TOWN OF PARADISE VALLEY

Smoke Tree Resort

Major Special Use Permit Amendment

Town Council Work Study Session

5. Viewsheds.

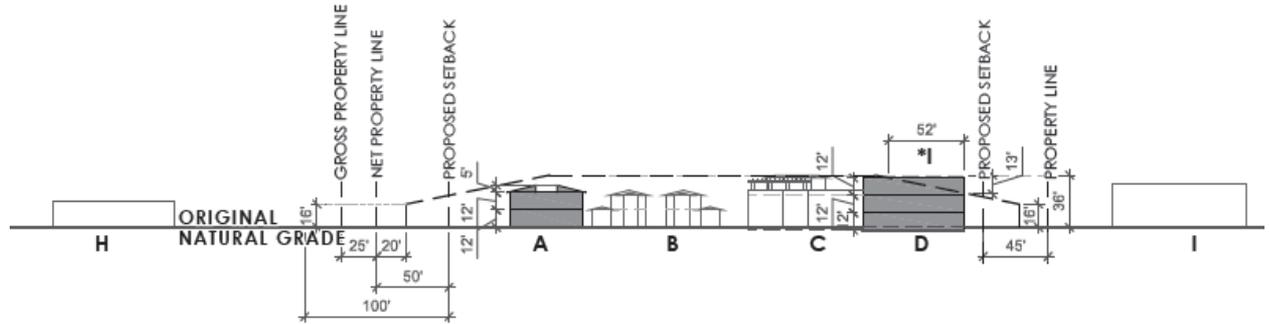
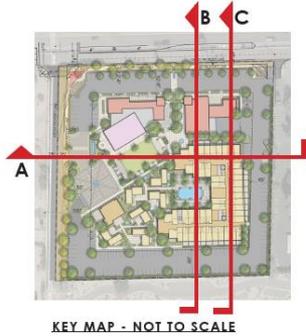
The Planning Commission shall consider the impact to adjoining properties of any encroachment outside of the imaginary plane suggested by the Open Space Criteria. Due to the size of this property being one quarter the suggested 20-acre size per the Special Use Permit Guideline and the location adjoining other commercial uses, a limited amount of encroachment may be permissible. Structures are suggested to generally stair-step from one-story/lowest height closer to the subject site property lines to not more than three-story/36 feet in height from Lincoln Drive, Quail Run Road, and the adjoining Andaz resort. The overall mass of the structures shall be reviewed to make sure it is of appropriate scale and special consideration shall be given to the views from the south side bordering the Andaz resort and the west side bordering Quail Run Road.

- A. Encroachment to the open space criteria limited to the north, along Lincoln Drive, and to the east, along Lincoln Medical Plaza**
- B. Lowest heights (24-30' from ONG) along Quail Run and Lincoln Drive, highest heights (36' from ONG) at southeast corner of site**
- C. 60' setback maintained from Andaz**

SECTION A - cut 150' from south property line
scale: 1" = 90'-0"

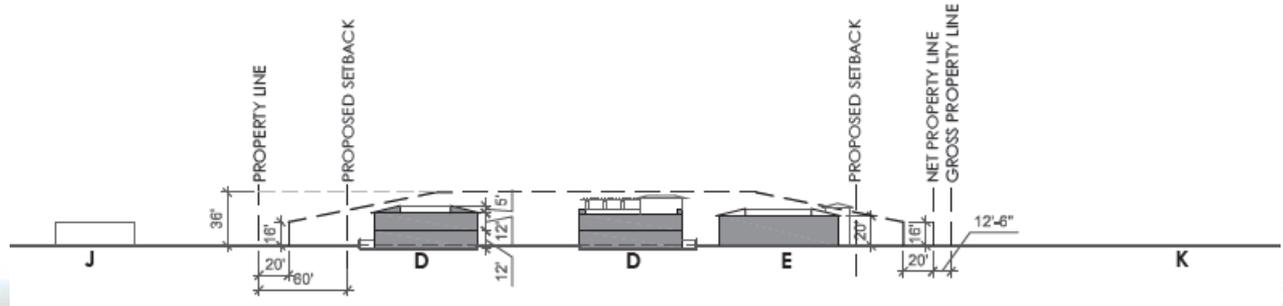
OSC	
North	Encroach
East	Encroach
South	Comply
West	Comply

8. Landscaping.

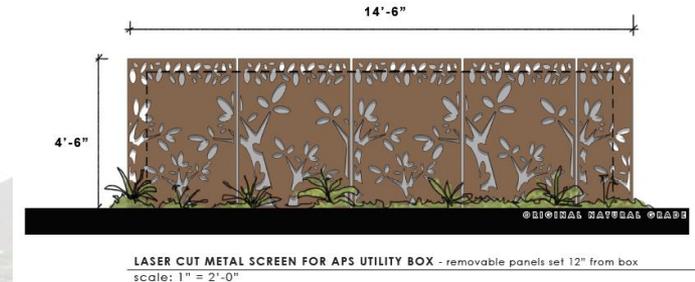
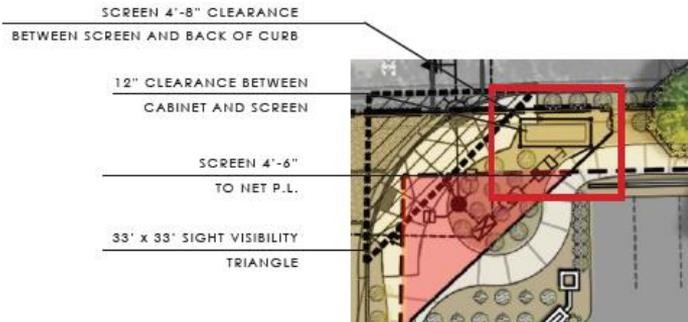
Attention shall be paid to the landscaping along Lincoln Drive and along Quail Run Road. A landscape plan shall be required. Hardscaping and pedestrian access shall be considered with the landscape plan. Special attention shall be given to the Lincoln Drive frontage as this is a gateway to the Town. The Draft Visually Significant Corridors Plan shall be considered as well as cohesion with the planned landscape improvements along the north side of Lincoln Drive. A stipulation may be considered to ensure replacement of any landscaping should it die.

- A. Landscaping along Lincoln Drive is in line with the SUP Guidelines and Visually Significant Corridors Master Plan, although some landscape lighting is proposed within the right-of-way which is not permitted**
- B. Similar planting density and geometric configuration as those improvements proposed on the north side of Lincoln Drive**
- C. Pedestrian access provided at two locations along Lincoln and one along Quail Run Road**

1. STREET CORNER SIGNAGE - 48 SF MAX SIGN WITH BACKLIT LETTERS

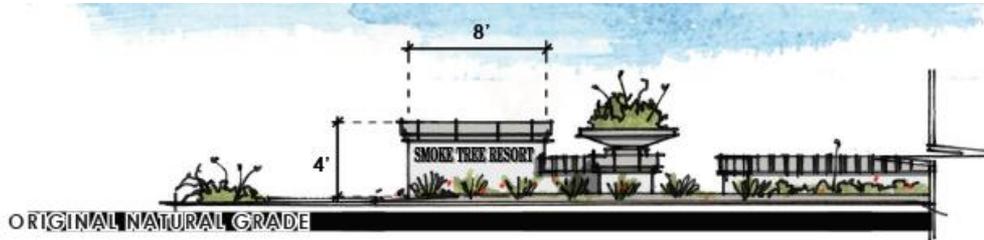
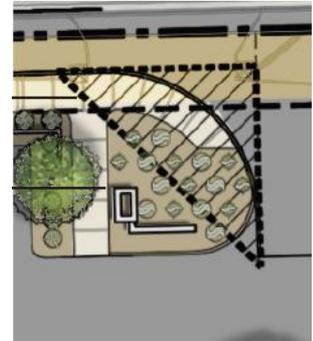
Planning Commission review shall focus on the impact of project sign location, dimensions, and illumination on the resulting impact to the streetscape. The Commission shall look at the broader signage plan for Lincoln Drive including proposed gateway signs, identification signs, and Ritz-Carlton and Lincoln Medical Plaza signage, and any Andaz signage that may be re-located to Lincoln Drive.

- A. All backlit illuminated signs**
- B. Primary street corner sign at Lincoln/Quail Run is 4' tall, 48 sq ft**
- C. Secondary Street Sign at shared driveway along Lincoln is 4' tall, 32 sq ft**
- D. Two entry signs on Quail Run Road, each is 4' tall and 32 sq ft**
- E. Building mounted resort auto court sign is 40 sq ft**
